# Wisconsin Department of Transportation

**Proposal #04: 2704-00-78**  
**Wisconn Valley Way**  
**Box Culvert**  
**Loc Str**  
**Racine County**

**3763-00-75**  
**CTH KR, V Mt Pleasant**  
**Kilbourn Ditch Box Culvert**  
**CTH KR**  
**Racine County**

This is Addendum No. 02, which provides for the following:

Addendum No. 02  
ID 2704-00-78  
Revised Sheet 11  
August 6, 2018

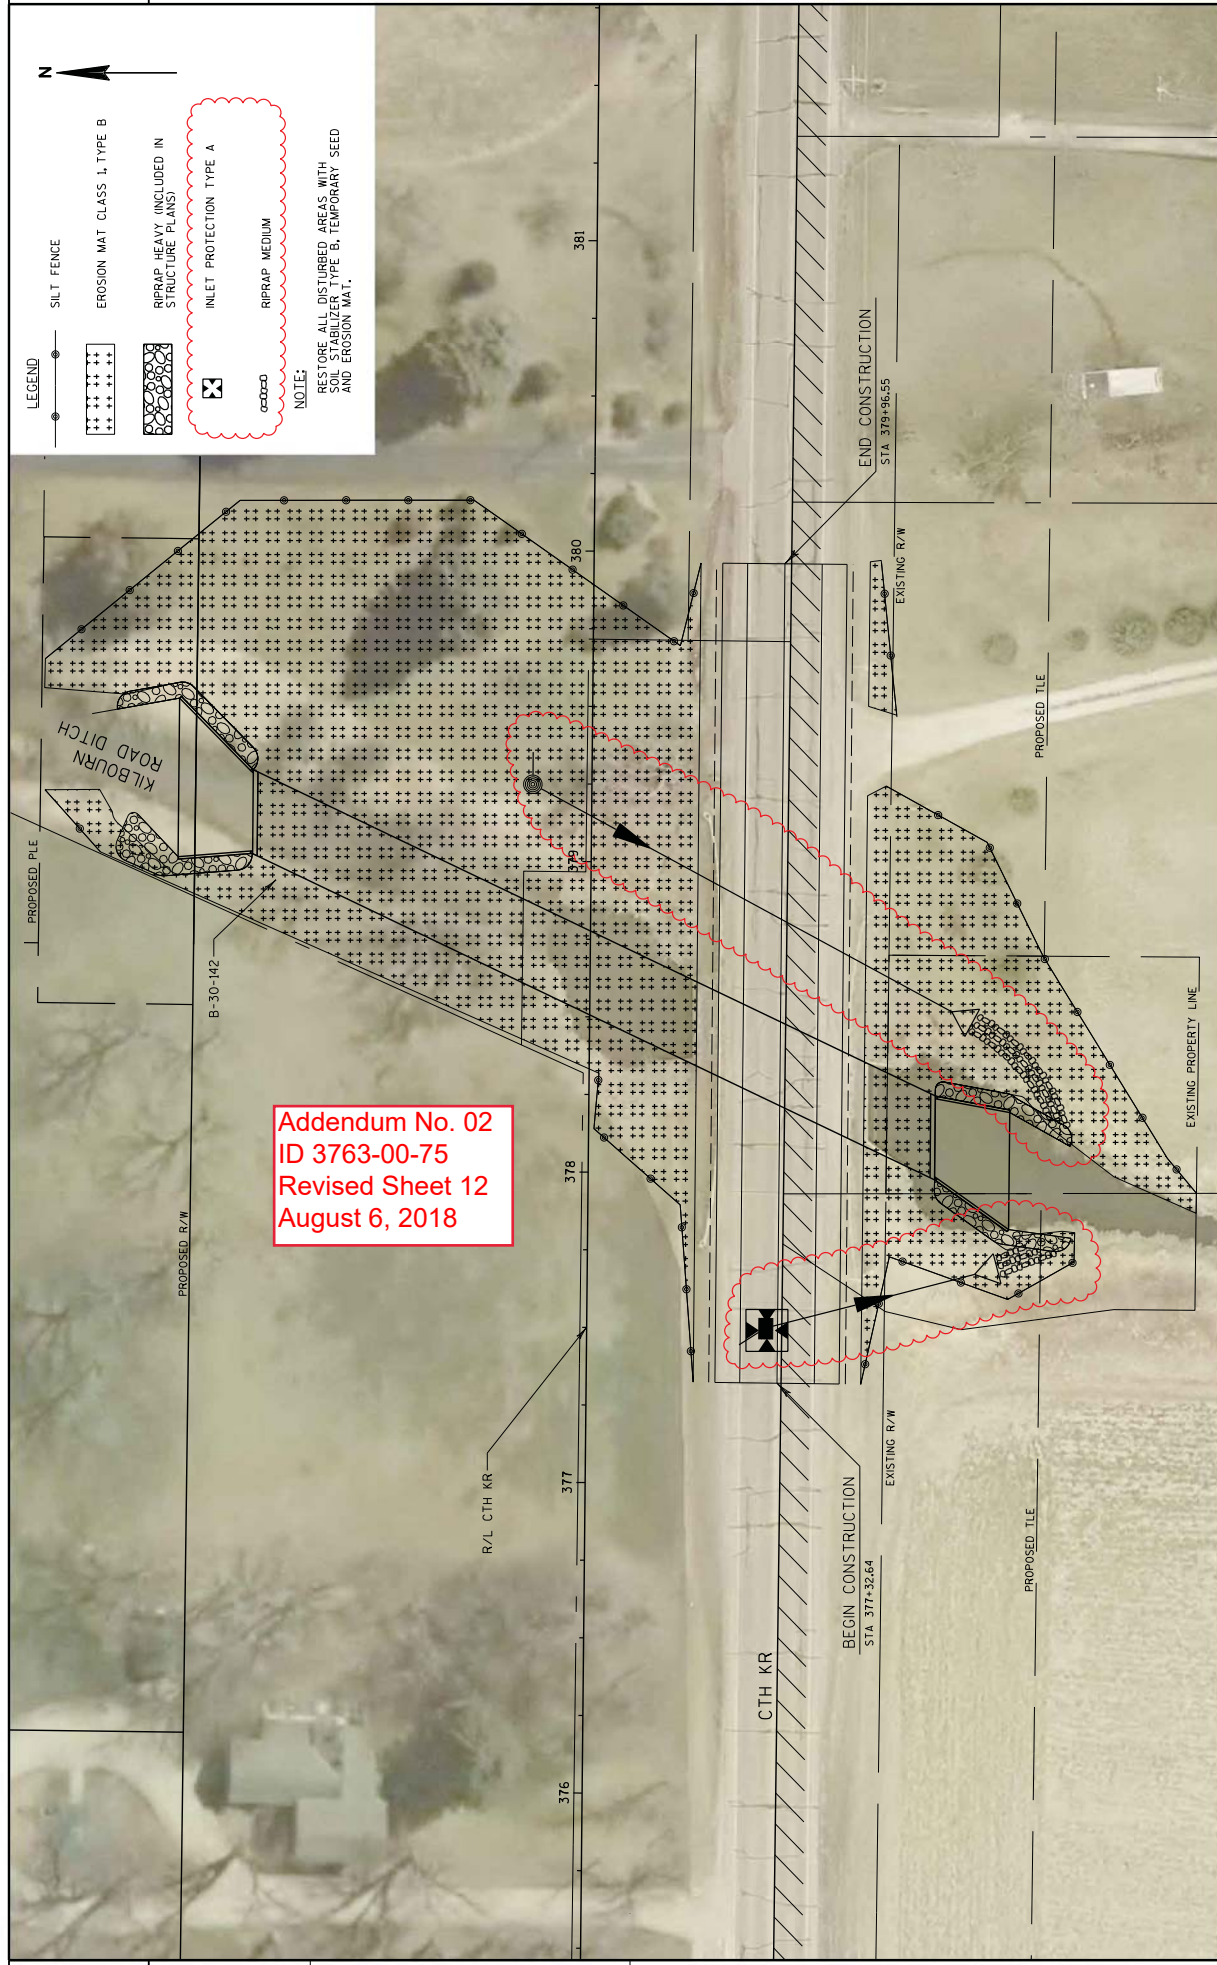
Revised Plan Sheets	
Plan Sheet	Plan Sheet Title (brief description of changes to sheet)
11	Erosion Control (added riprap, updated legend)
12	Erosion Control (added riprap and inlet protection, updated legend)
57	Structure B-30-142 (removed temporary shoring from plan view)
58	Structure B-30-142 (removed bid items 511.1200.001 & 511.2200.001)
60	Structure B-30-142 (removed temporary shoring from plan view)

Addendum No. 02  
ID 3763-00-75  
Revised Sheet 58  
August 6, 2018

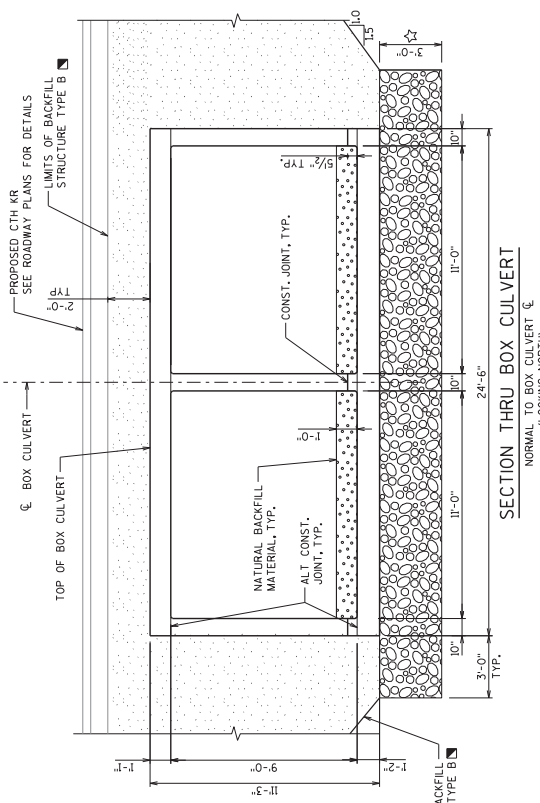
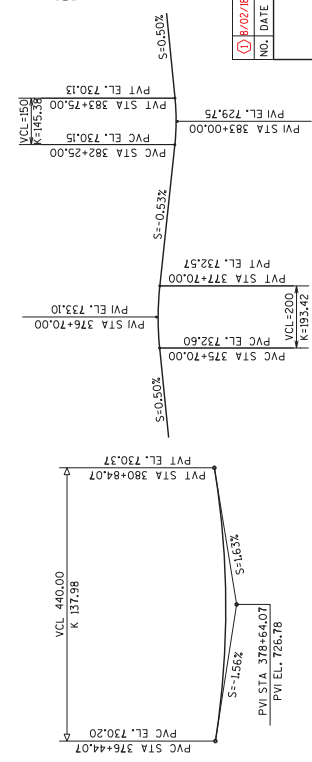
REVISION: **REMOVING TEMPORARY SHORING**

**Addendum No. 02**  
**ID 3763-00-75**  
**Revised Sheet 60**  
**August 6, 2018**

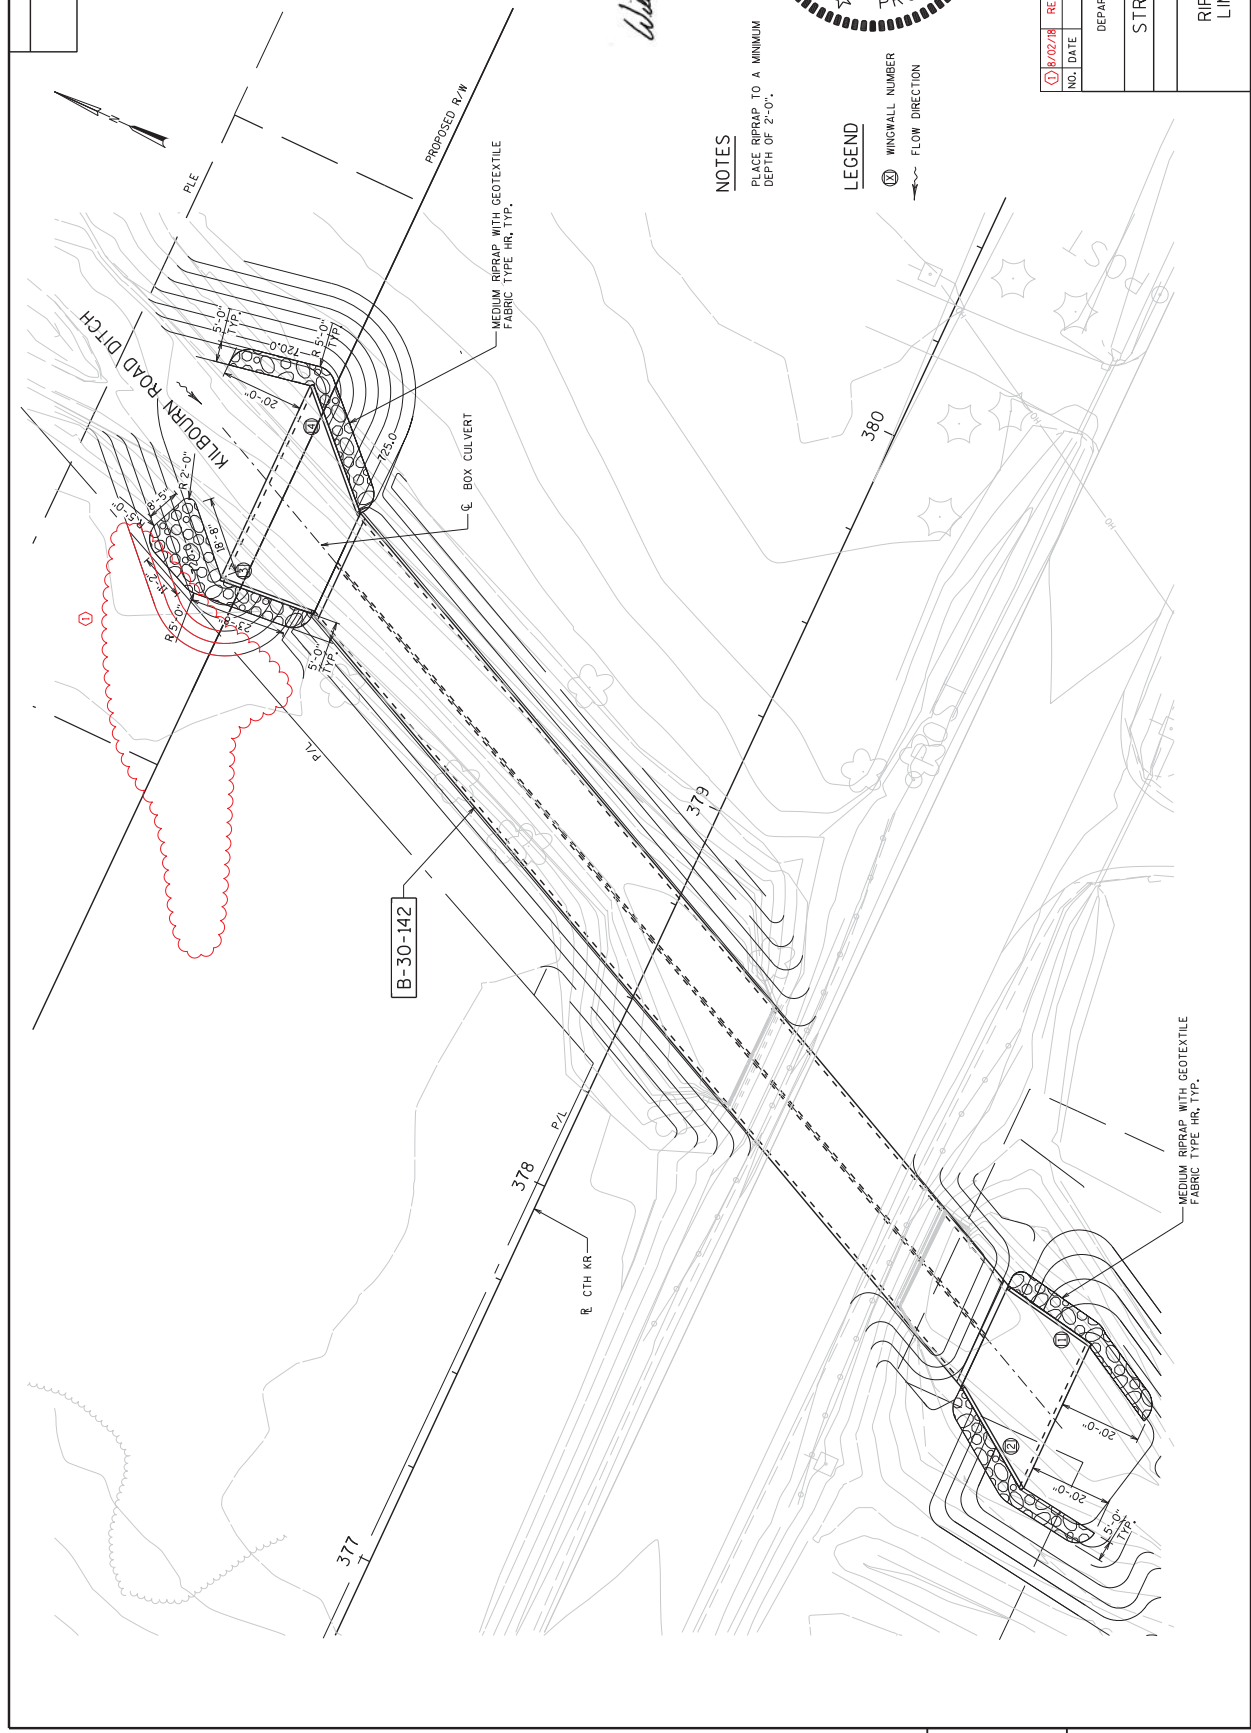
NO.	DATE	REVISION	BY
1	8/02/18	REMOVE TEMPORARY SHORING	SMC
